SUNDRY NOTICES AND REPORTS ON WELLS

Dugan Production Corp.

Lucerne #3

Gas Pipeline R-O-W Route Change for Lucerne #3

Project Area Map

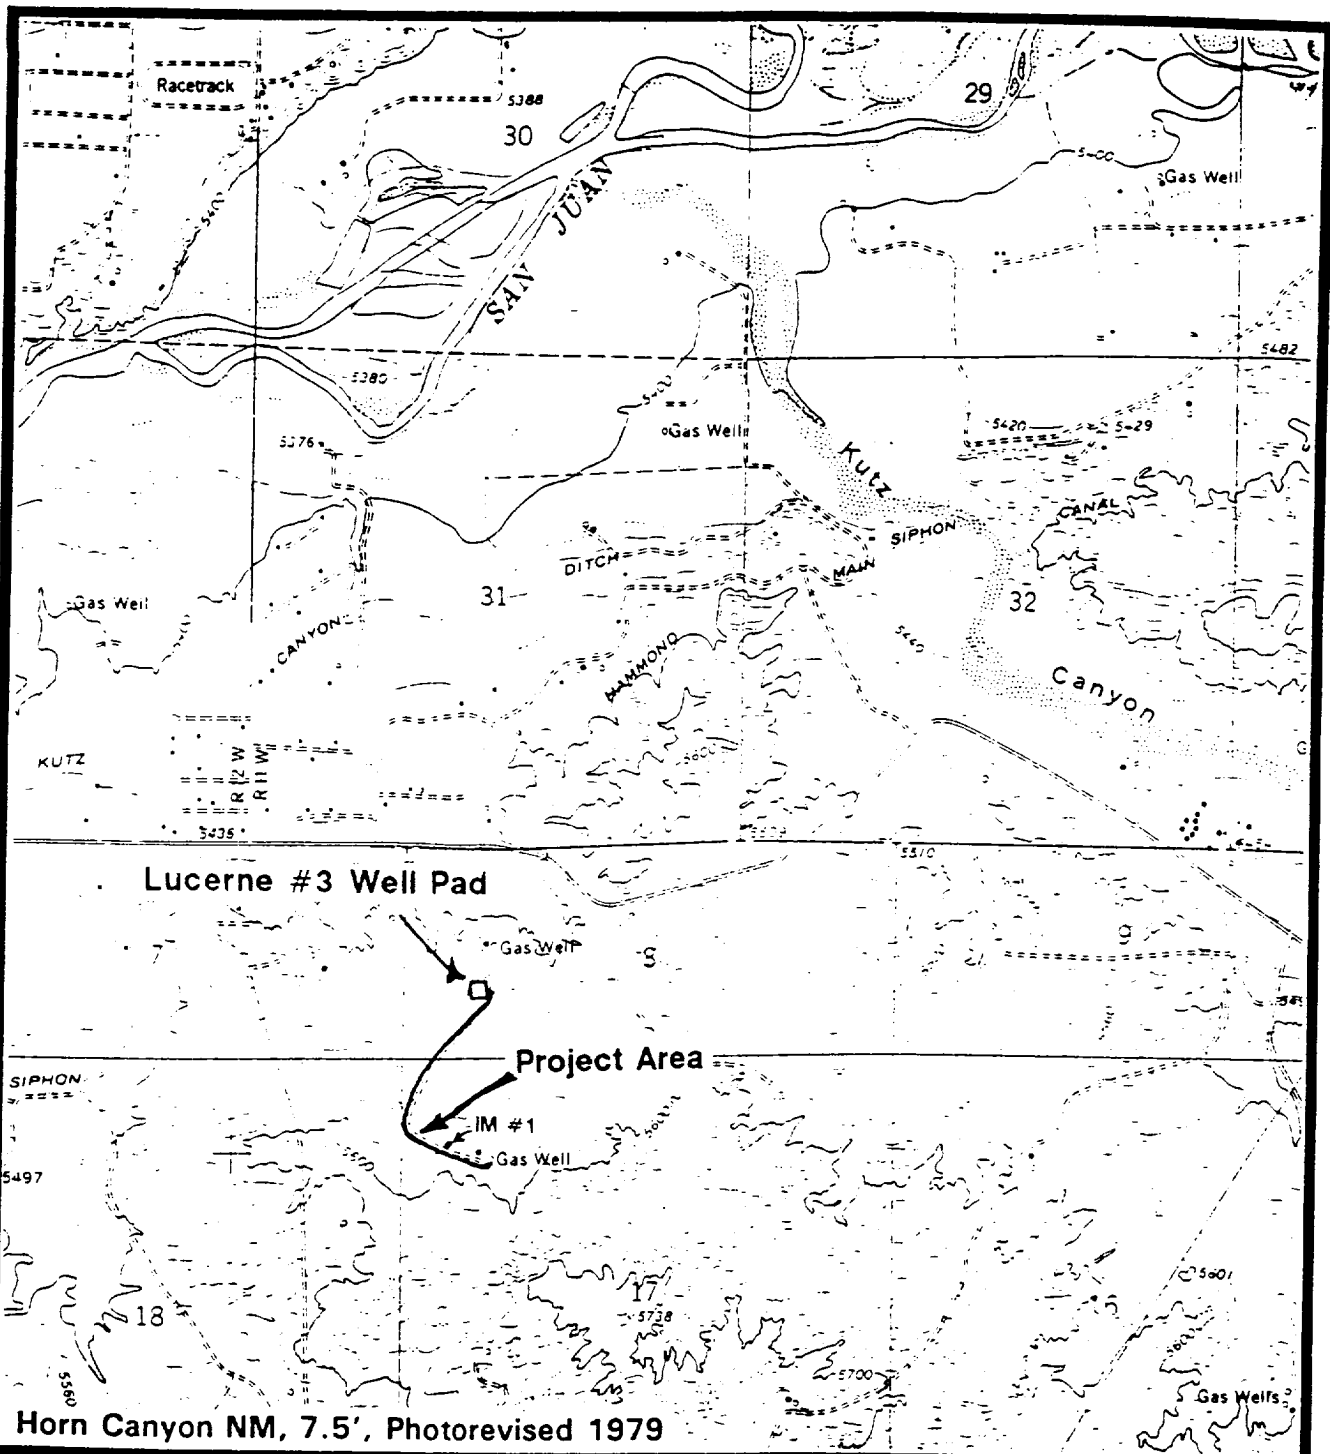
Dugan Production Corp. requests approval to change the pipeline R-O-W route that was approved in APD dated 10-29-96. Dugan requests approval to construct an on-lease buried 2-7/8" diameter steel pipeline, 2300' in length and 30' in width, parallel with existing road, from Dugan's Lucerne #3 to El Paso Field Services lateral 73324-H, located in the NW/4 Sec. 17, T28N, R11W. Anticipated pipeline pressures will be approx. 30-40 psi. The proposed pipeline will be pressure tested to 150 psi. This pipeline R-O-W route change request is due to the area's natural gas transportation and marketing opportunities. Please refer to map which is attached and San Juan Archaeological survey report dated 11-15-96.
